SIB 34 02 24

RECALL 24V-104: INTEGRATED BRAKING SYSTEM

This Service Information Bulletin (Revision 14) replaces SI B34 02 24 **dated July 2025**.

RECALL 24V-104: INTEGRATED BRAKING SYSTEM (IB)

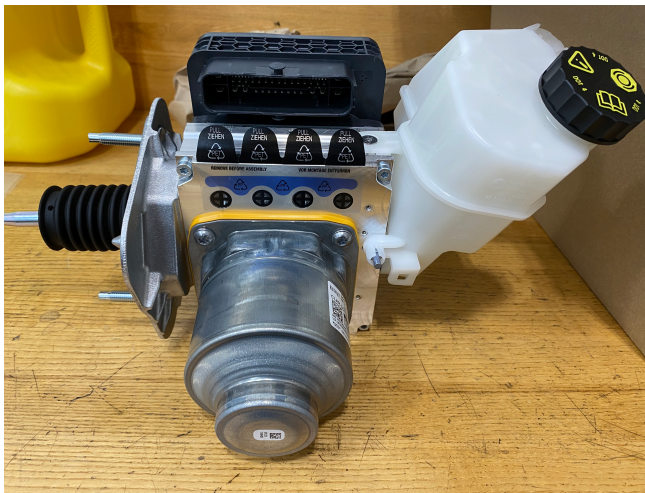
Replace the IB with either a “wet” pre-filled unit or a “dry” unfilled unit.

“Wet” IB pre-filled: Brake fluid reservoir is filled (arrow) and brake fluid line ports are plugged with bolts (circled)

5B67B85
5B72715
5B72716
5B6A736
5B77C55
